**PERMIT**  
**INDEXED**  
**TAX ID #05-441293**

**ON-SITE SEWAGE DISPOSAL SYSTEM**  
**HOWARD COUNTY HEALTH DEPARTMENT**  
**BUREAU OF ENVIRONMENTAL HEALTH**

SUBDIVISION: Homewood Crossing LOT NUMBER: 1

ADDRESS: 11401 Hunt Crossing Court  
~~4903 Valley View Overlook~~ PROPERTY OWNER: Toll MD III, LP

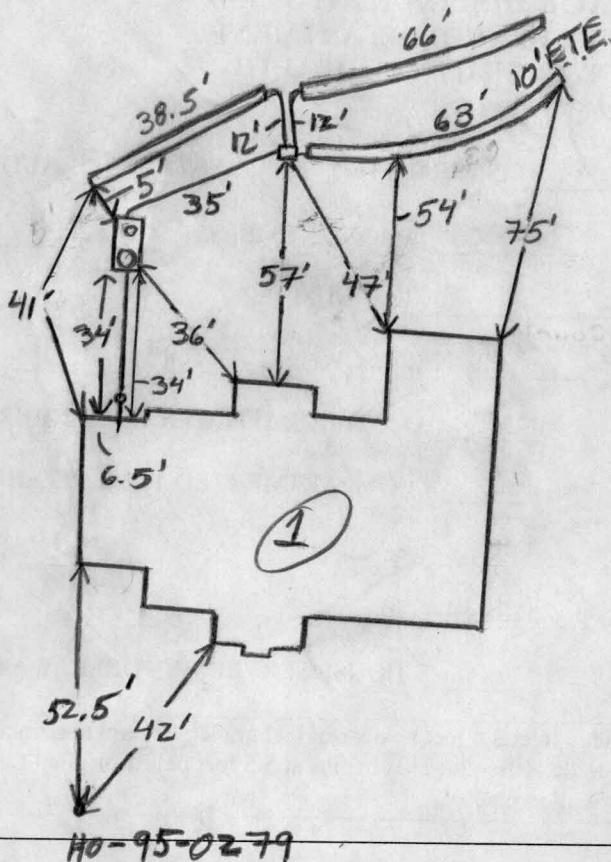
PRE-CONSTRUCTION 9/28/06 Too much Fill @ top left

corners of SOA. Do not proceed w/ layout and installation

INSTALLATION until fill is removed (KW) 10/2/06 Contacted Toll

Brothers Project Manager, told him to remove fill and Re-Survey SOA.

Need new layout (KW) 10/24/06 Fill removed. To install

two 65' trenches on contour towards left lot line

and one 40' trench running towards right lot line. Tank

and plumbing into house connected. D box set, one

63' trench dug out no pipe. (KW) 10/25/06 All 3 trenches

installed per installation. Made contractor install 42" riser on

front of S.T. → Builder should not have no more than 40" of fill

on Tank. (156) System OK to cover (KW)
